Illinois Department of Transportation

SUBJECT: St. Louis Downtown Airport
Cahokia, Illinois
St. Clair County
Illinois Project Number: CPS-4976
Contract No. SD061
Item No. 02A, April 29, 2022 Letting
Addendum A

NOTICE TO PROSPECTIVE BIDDERS

Clarifications to Plans and Special Provisions

**SITE STOCKPILE &
CHANNEL OVERVIEW**

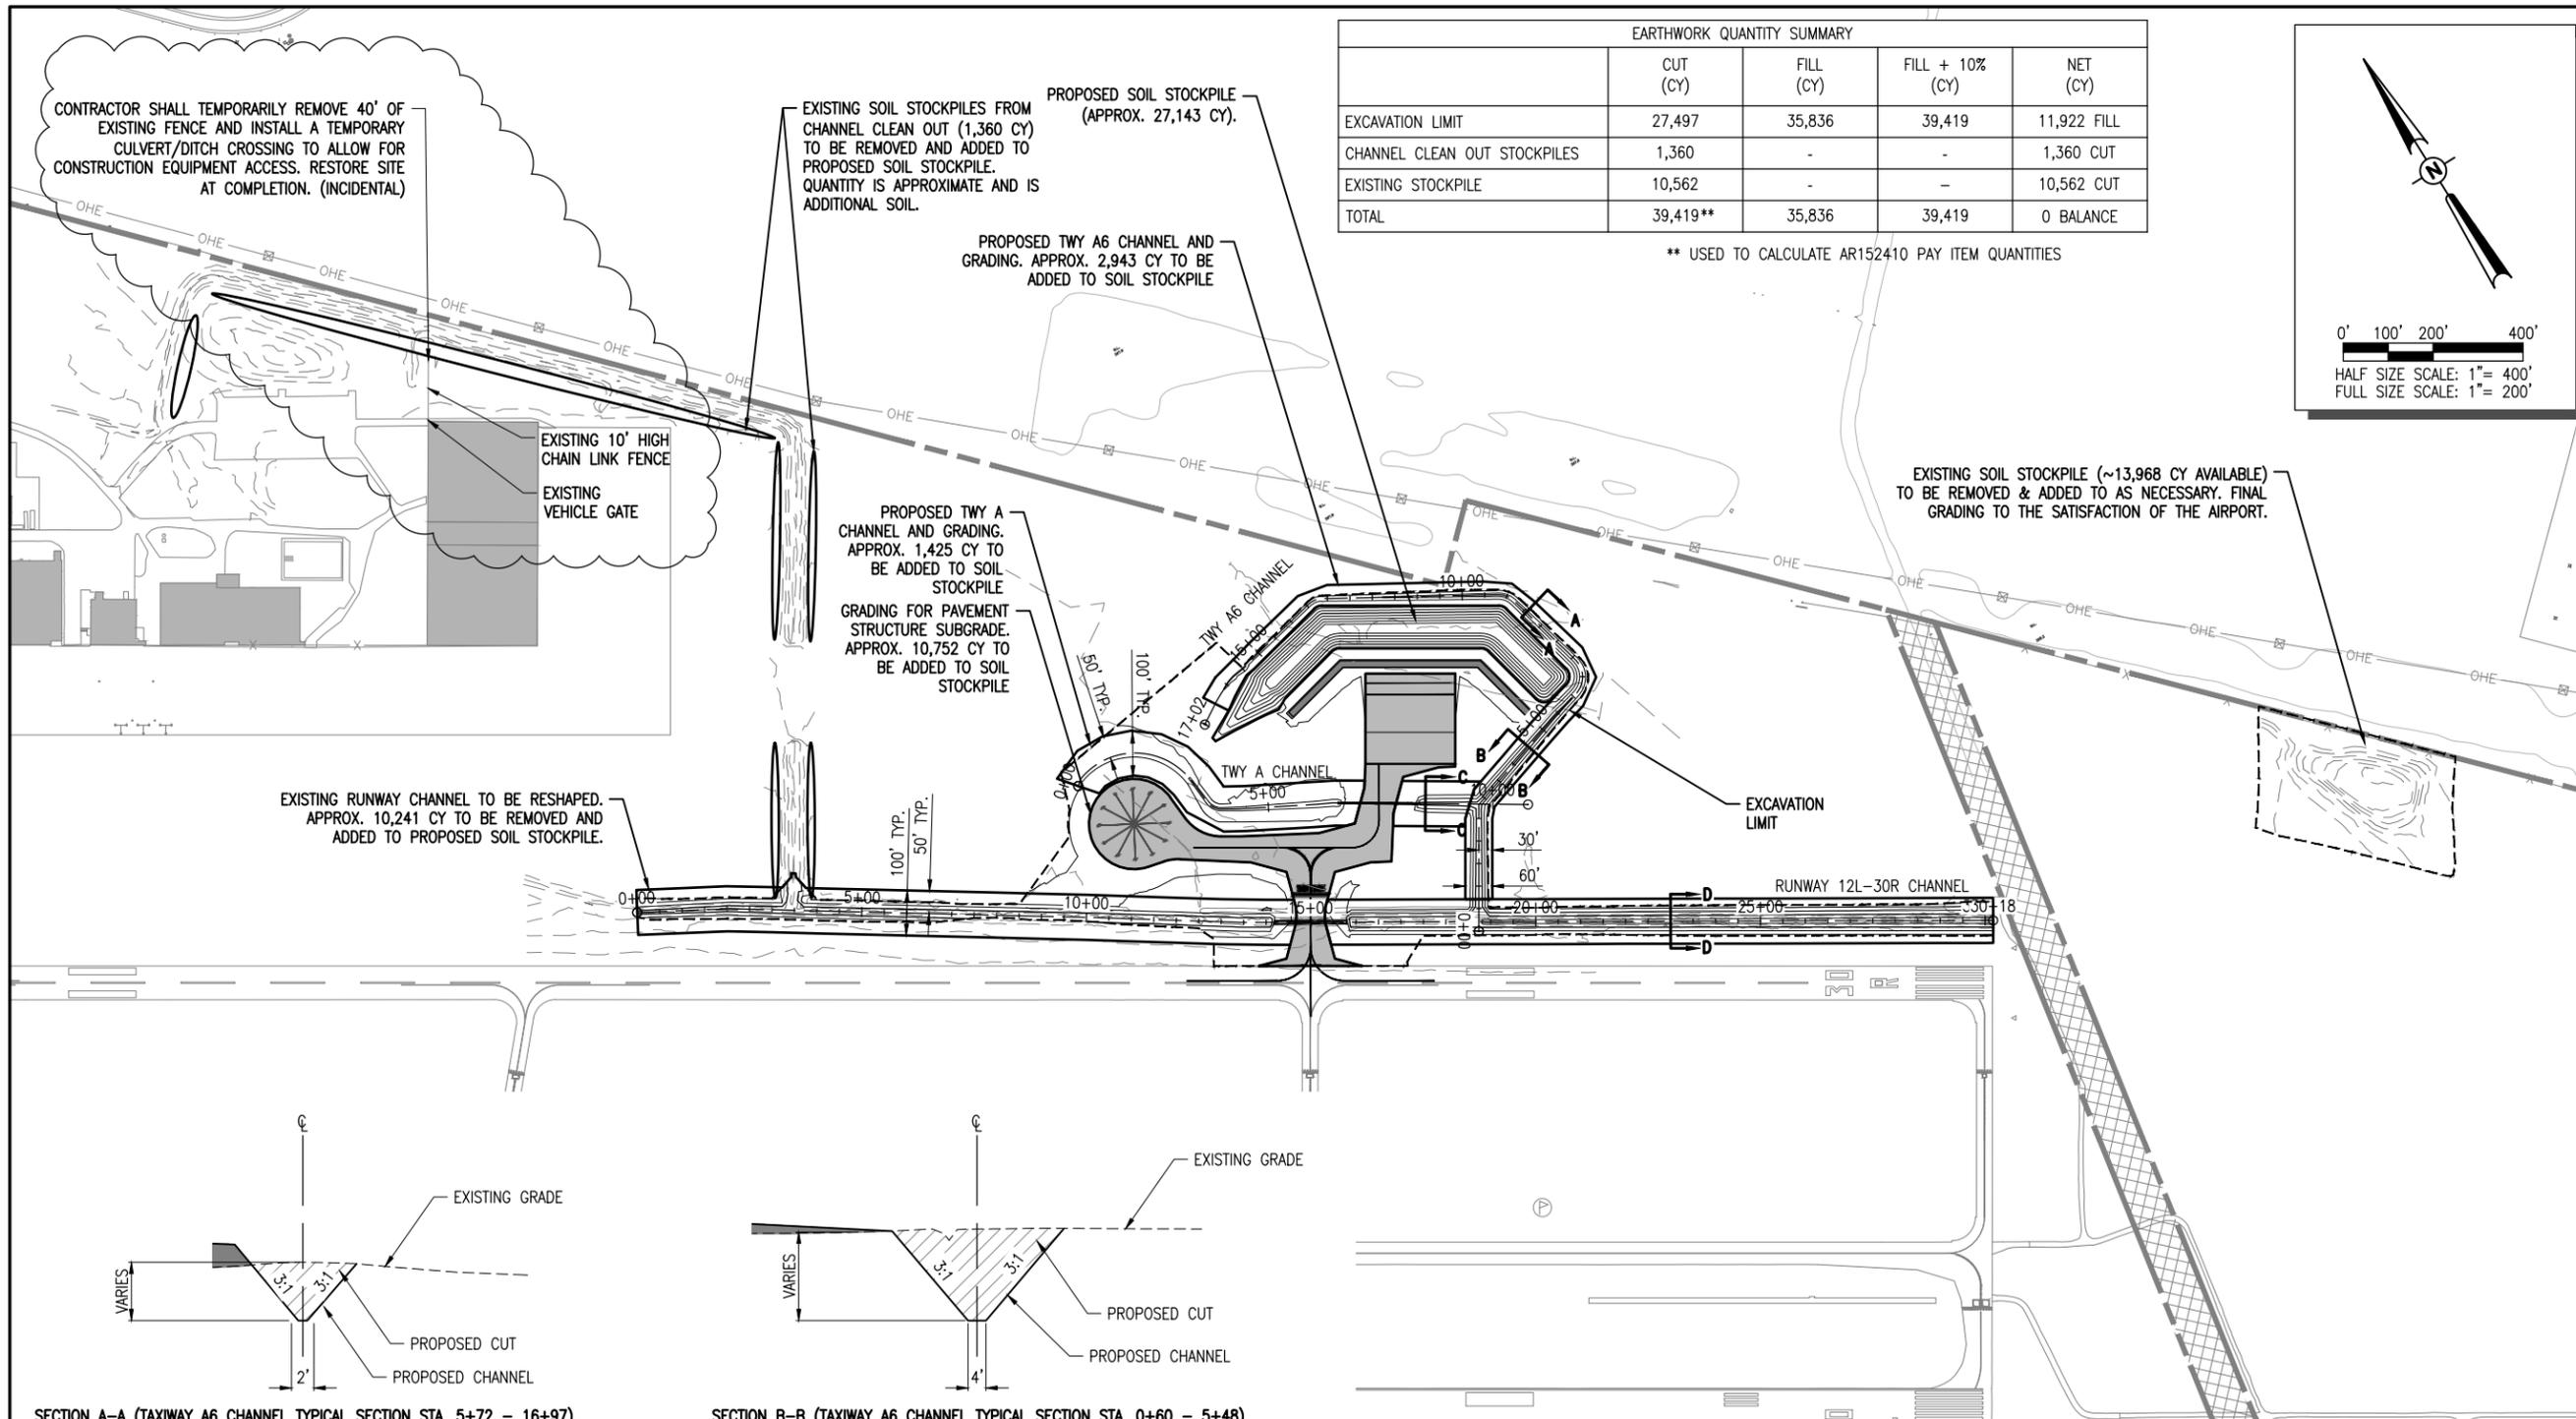
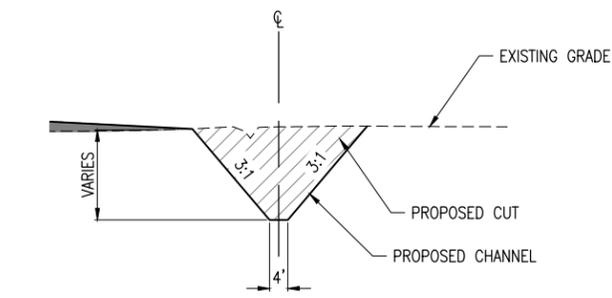
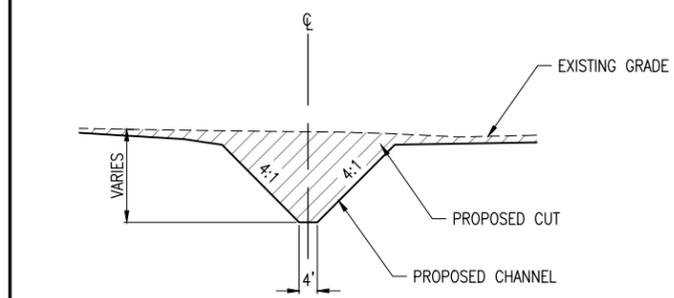
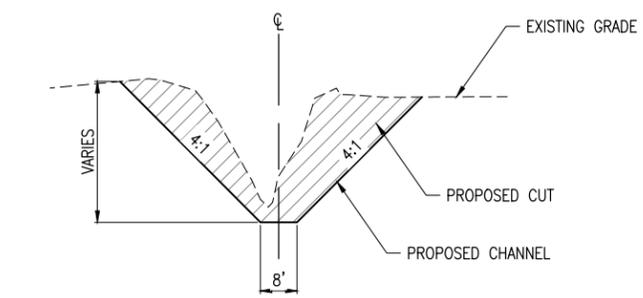
Plan Sheet No. 9, Site Stockpile & Channel Overview: added site access notes
Plan Sheet No. 22, Jointing Plan: revised appearance of linework to match legend
Plan Sheet No. 23, Jointing Details: revised reinforcement note
Plan Sheet No. 25, Box Culvert Details – Sheet 1: clarified bedding details

NO.	DATE	DESCRIPTION
△	4/22/22	ADD NOTES
		JRH CWS BSS
		DES DWN REV
